**Officer South Employment Precinct Structure Plan  
Draft Amendment C274card**

**Victorian Planning Authority Projects Standing Advisory Committee Referral 8 Report**

**6 June 2024**

**Figure 4 – Conservation Concept (Cardinia Creek)**  
 Officer South Employment Precinct Structure Plan

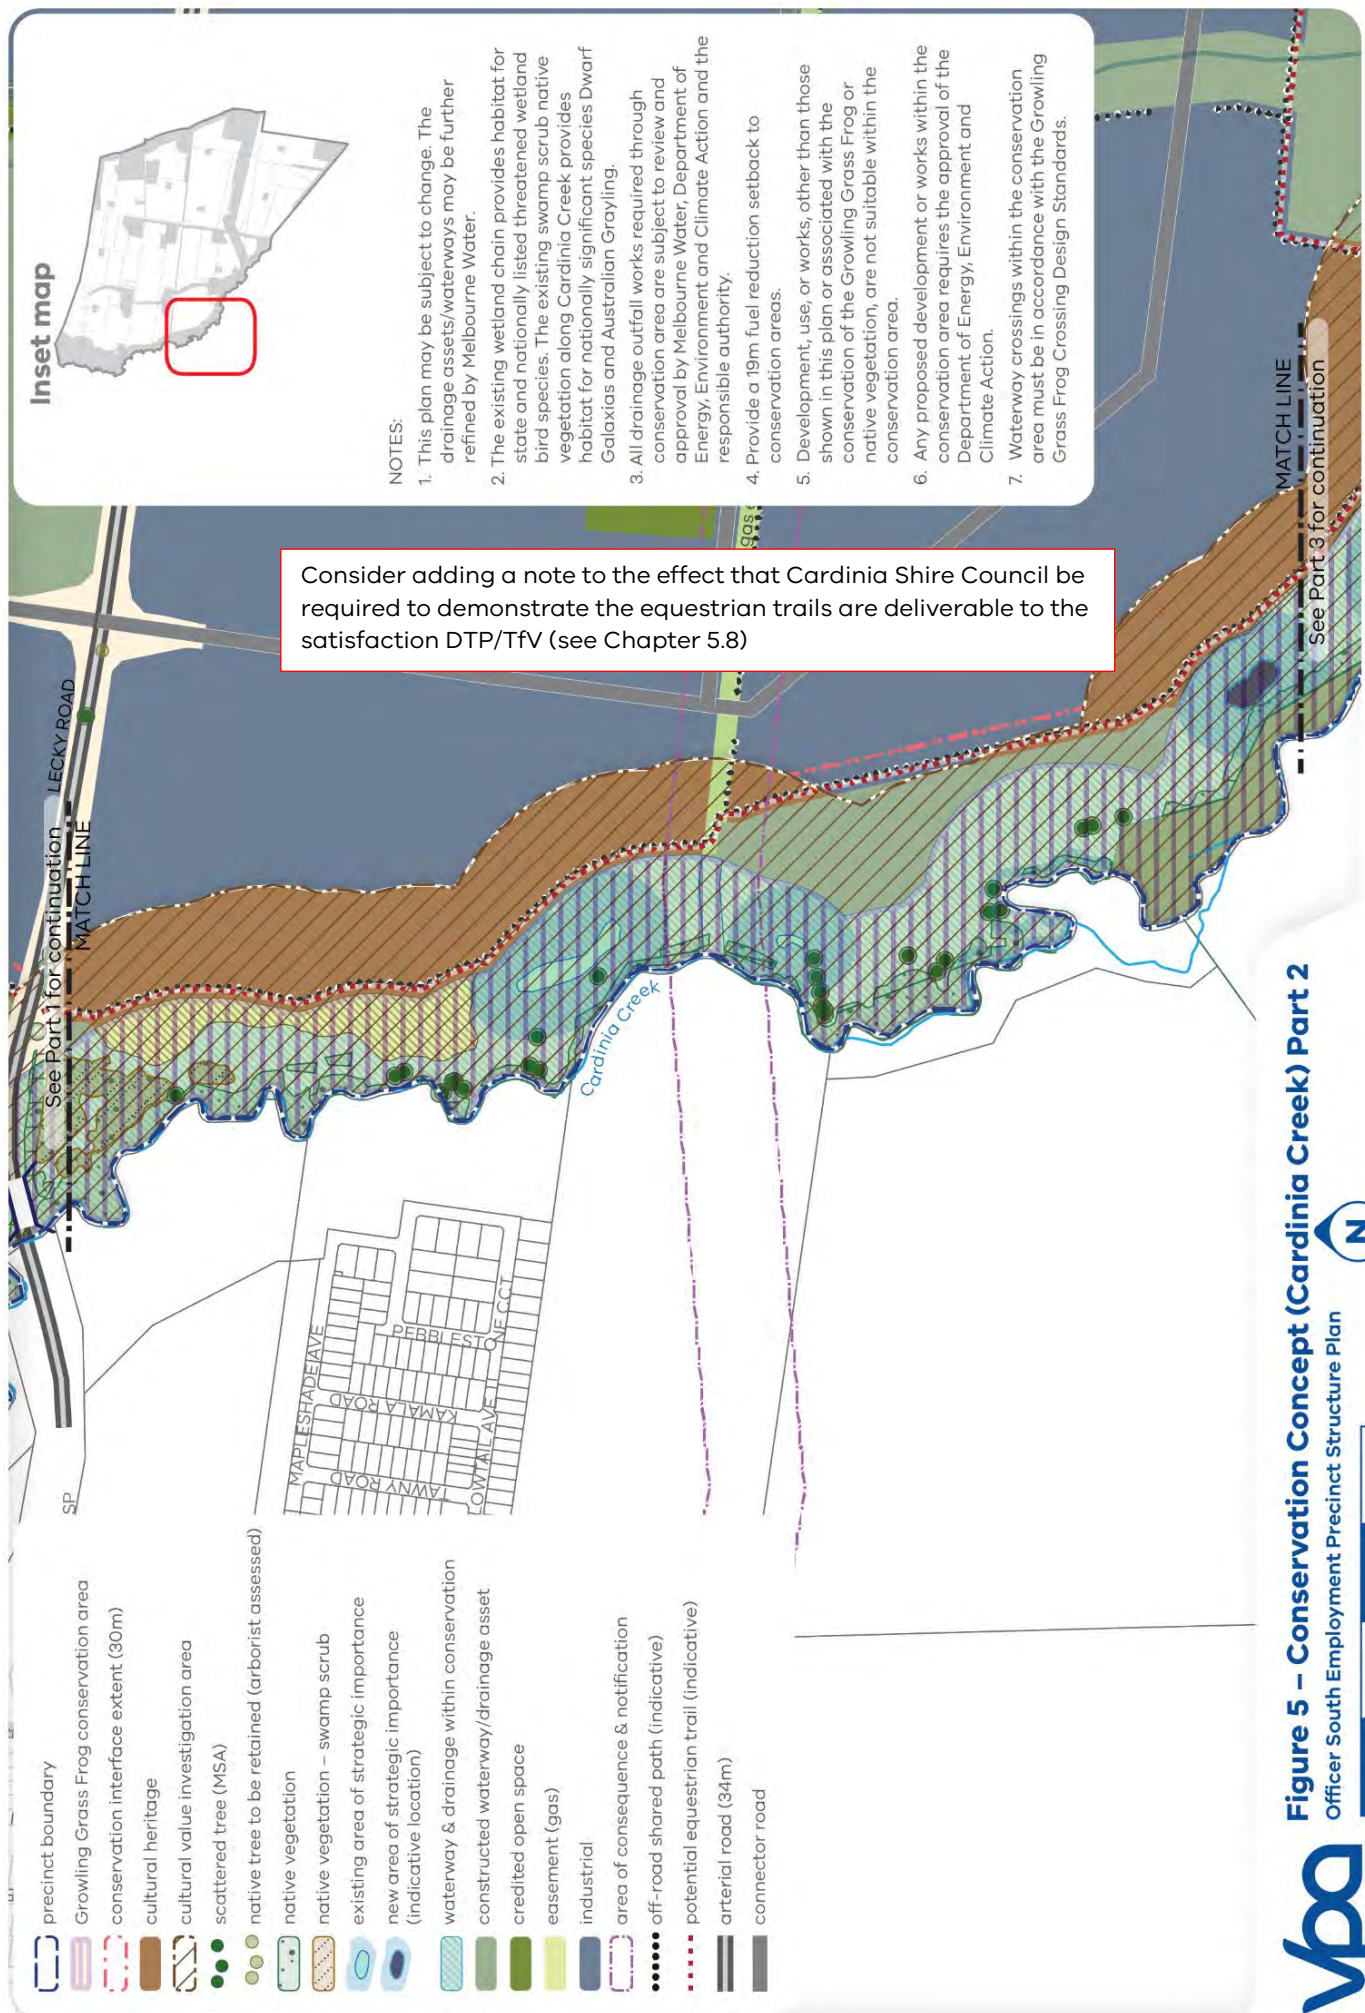
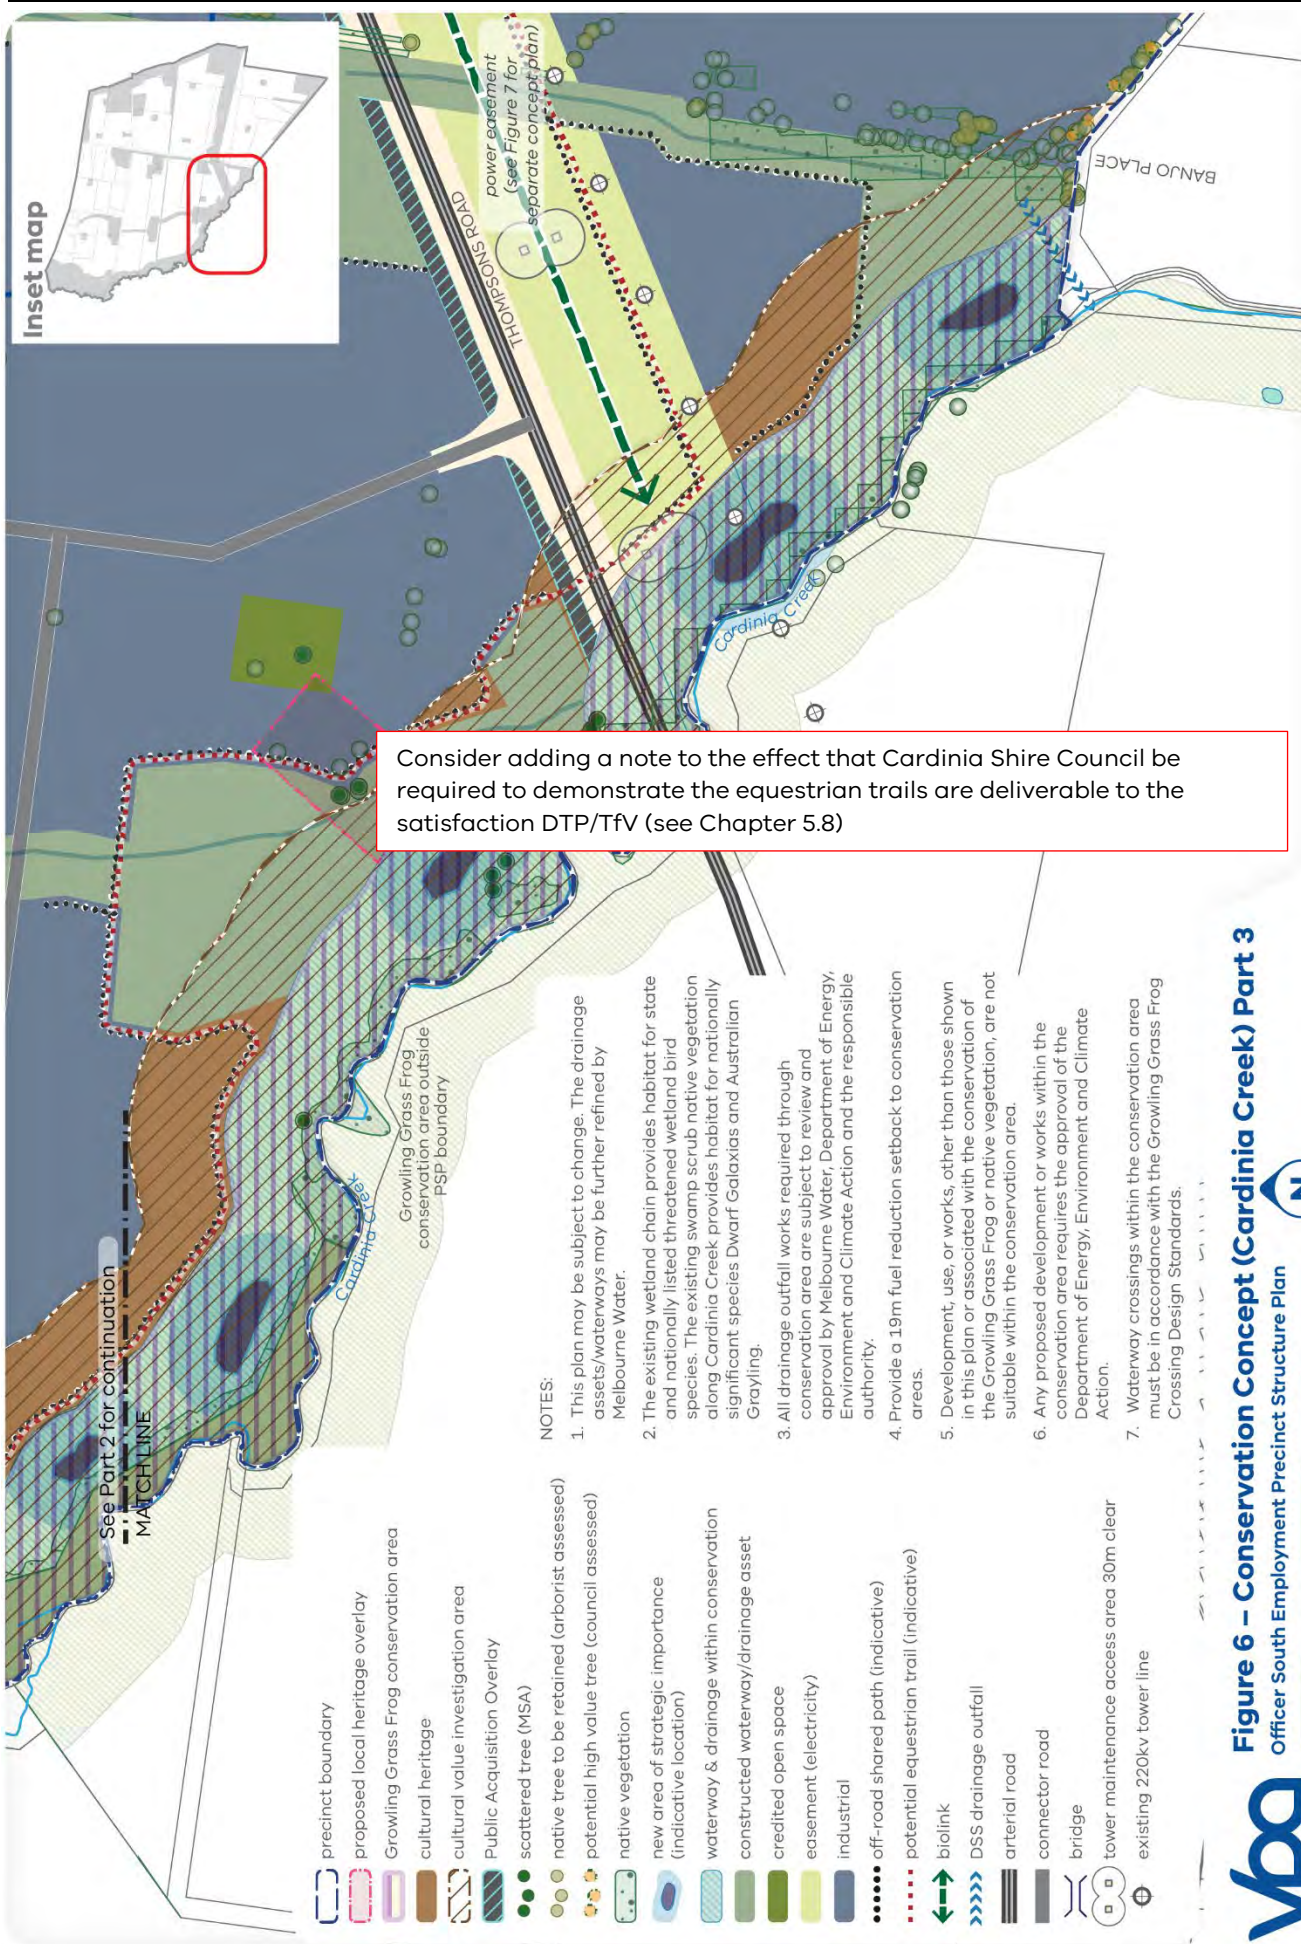
Consider adding a note to the effect that Cardinia Shire Council be required to demonstrate the equestrian trails are deliverable to the satisfaction DTP/TfV (see Chapter 5.8)

**Figure 7 – Power Easement Concept**  
 Officer South Employment Precinct Structure Plan

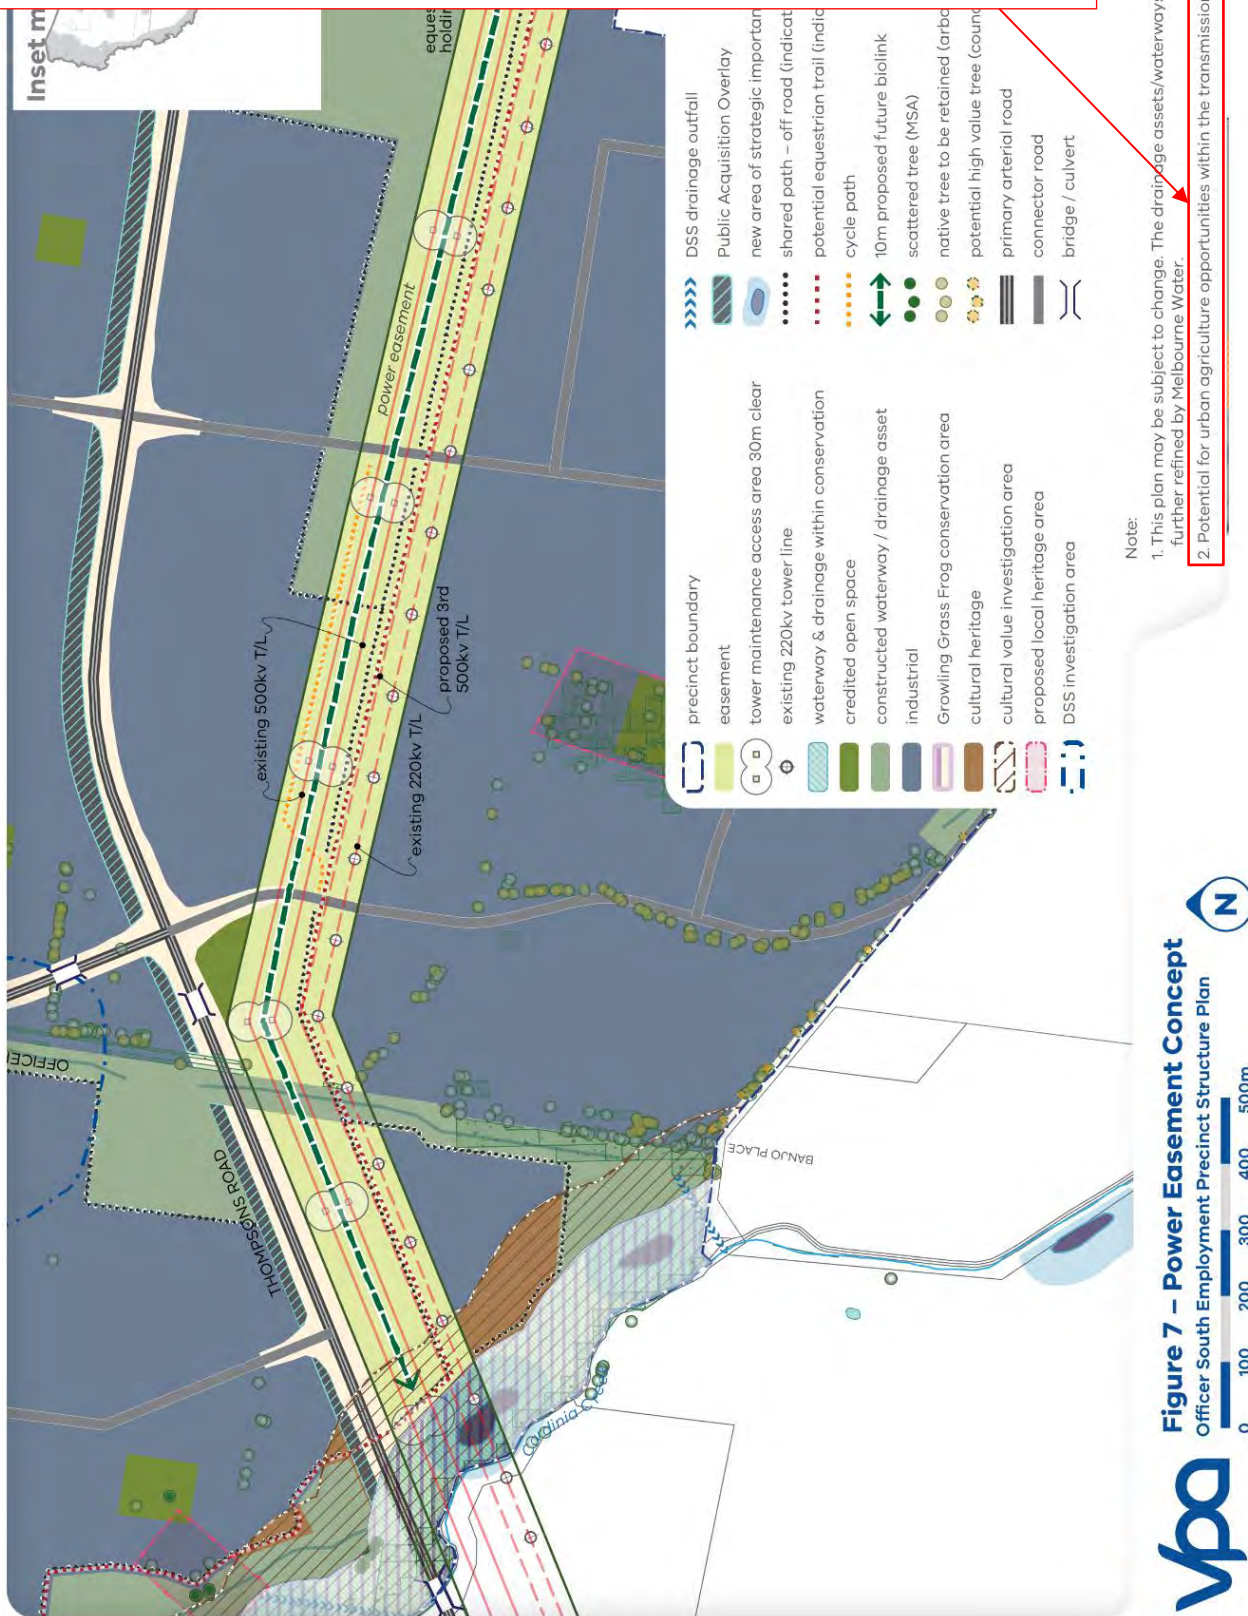
Consider adding a note to the effect that Cardinia Shire Council be required to demonstrate the equestrian trails are deliverable to the satisfaction DTP/TfV (see Chapter 5.8)

Primary Arterial 6 Lane – 41m – Officer South Road with waterway interface

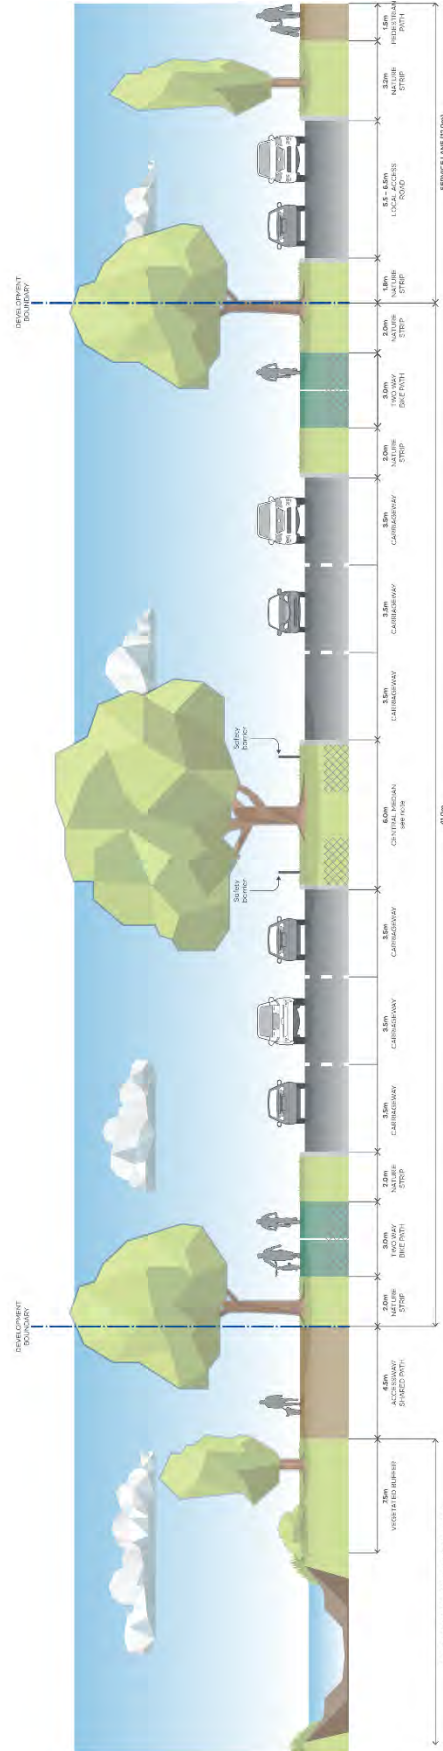
**Recommendation 6(p):** add notes to relevant cross sections to:
